London Biggin Hill Airport Airspace Change Proposal

Stakeholder Update

Date: 27th September 2019

Figure 1 – Original Proposed IAP Design for the Initial Sponsor Consultation

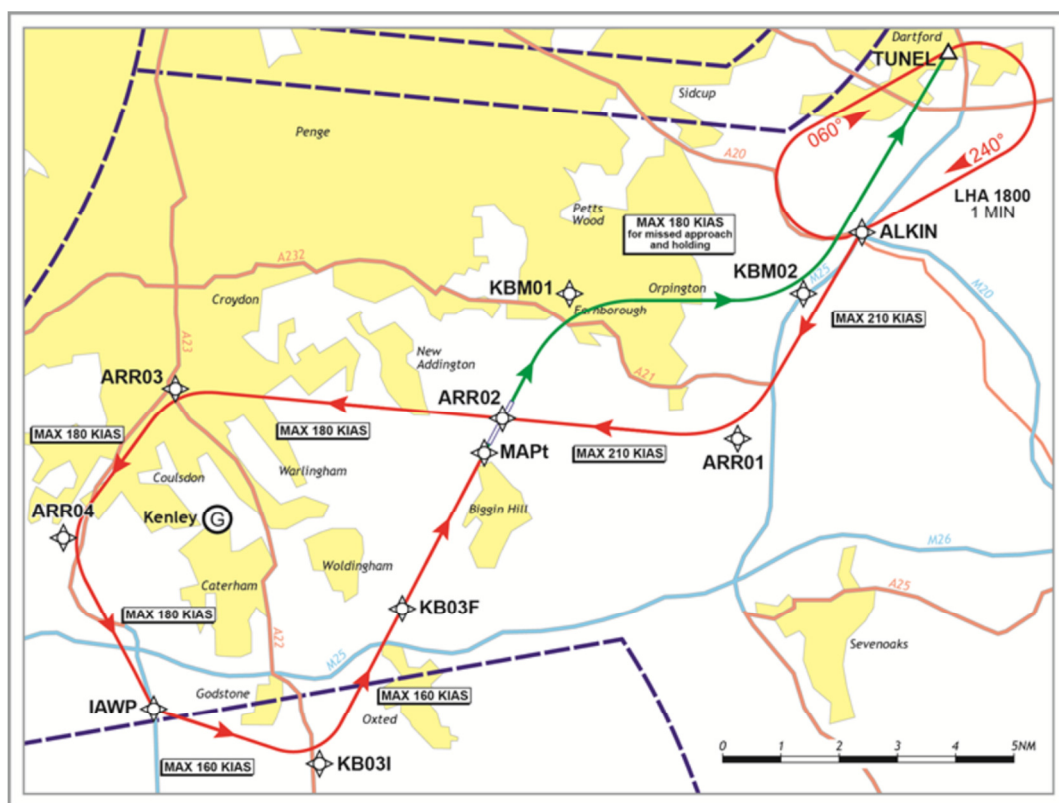
The original Sponsor Consultation took place during the period 18 November 2015 to 26 February 2016. A number of important issues, both of an operational and an environmental nature, were identified by the responses to the Consultation, which needed to be addressed and resolved before the proposal could be progressed further.

The key operational matters related to the interaction of the proposed procedure with the flight profiles of departure routes from London Gatwick and London Heathrow Airports.

The environmental concerns related to the alignment of the proposed IAP over communities on the ground that are not currently overflowed, and the desire by these communities to reposition the nominal route of the proposed IAP away from their location. Whilst the procedure design had nominally routed aircraft over built up areas which are already subject to high levels of background noise, both from ground and air vehicles, this met with objection from some communities and Local Planning Authorities.

In view of the responses received, LBHA reviewed the alignment of the proposed IAP and an alternative flight path route was developed which reduced the number of communities overflowed. However, in some areas it had not been possible to develop a realignment of the procedure which would take nominal tracks away from built-up areas. As a result of the changes, it was determined that a further consultation would be required before the proposal could be submitted to the CAA.

Figure 4 – Final Proposed IAP Design Routing (Western Portion)

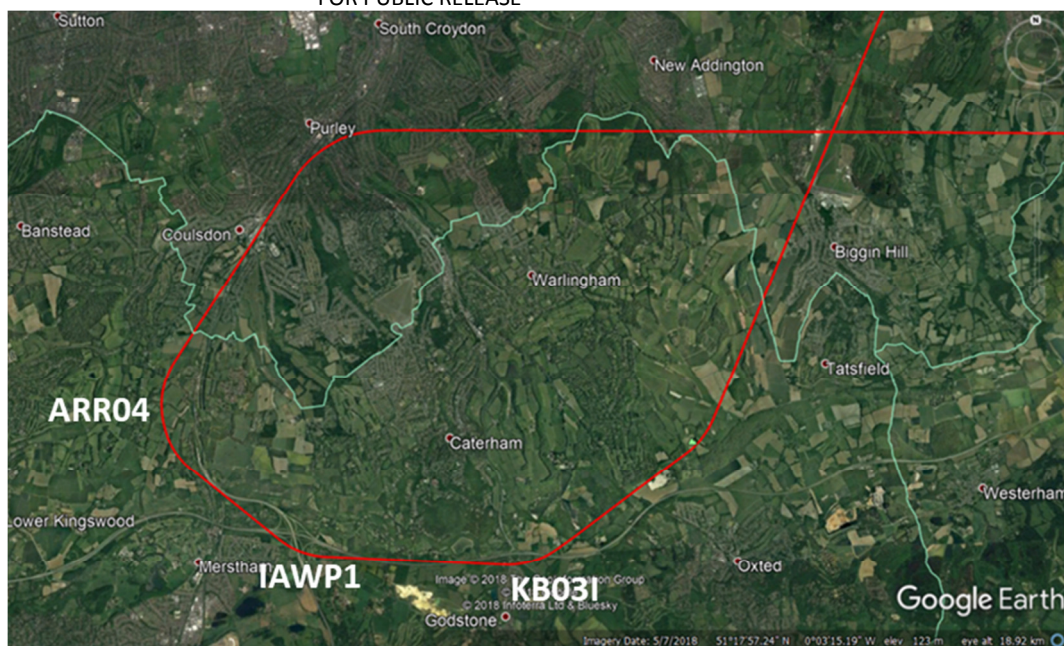
Figure 3 below shows the amended routing that the final proposed IAP will follow. The key changes that have been made to the procedure, as shown in Figure 4 and Figure 5, are as follows:

- Waypoint ARR04 (KBW02 in Figure 5) has been moved further south west avoiding direct overflight of Hooley.
- Waypoint IAWP (IAWP1 in Figure 5) has been moved east to route over the junction of the M25 and the M23, therefore avoiding Merstham.
- Waypoint KB03I has been moved further south (but not as far south as the original IAP design for the Sponsor Consultation) moving the procedure closer to the M25.
- The new route is more aligned with both the M23 and the M25 to assist identification of the route to glider pilots operating in the local area.

Figure 5 – Final Proposed Procedure (red) Compared to the Revised Procedure (blue)

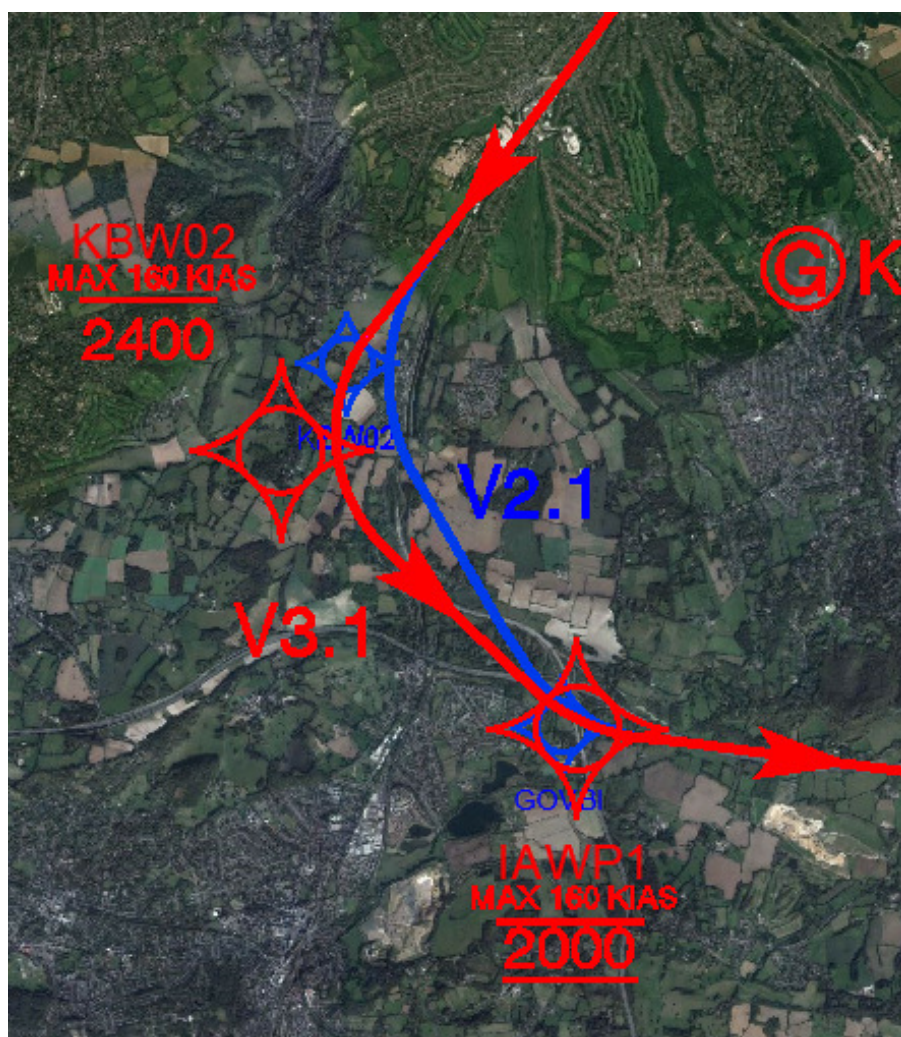
From the aviation perspective, the primary concern of the GA airspace user community was the re-positioning and reduced altitude of the procedure to place aircraft below controlled airspace and on an alignment coincident with the M25. The motorway is widely used as a visual navigational line feature by GA traffic to avoid CAS. Furthermore, there was concern regarding the interaction of LBHA traffic with GA traffic operating under Visual Flight Rules (VFR) from both Redhill and Kenley airfields.

From the community perspective, the majority of objections to the reconfigured IAP came from residents of Woldingham, and in particular from The Ridge on the southern edge of Woldingham. The consultees expressed concern over the nominal track of the reconfigured IAP which now overflies their community at too low a height over the high ground of The Ridge. There was support for some aspects of the reconfiguration of the proposed procedure in so far as the alignment was now along or north of the M25 and away from Bletchingley and Nutfield areas.

In Figure 5, the routing of the final proposed routing IAP is indicated in red, and is compared against the routing of the revised configuration of the procedure (shown in blue) that was shared with stakeholders during the second round of consultation, carried out between 27 February 2017 and 10 April 2017, and described in paragraph 2.4 above.
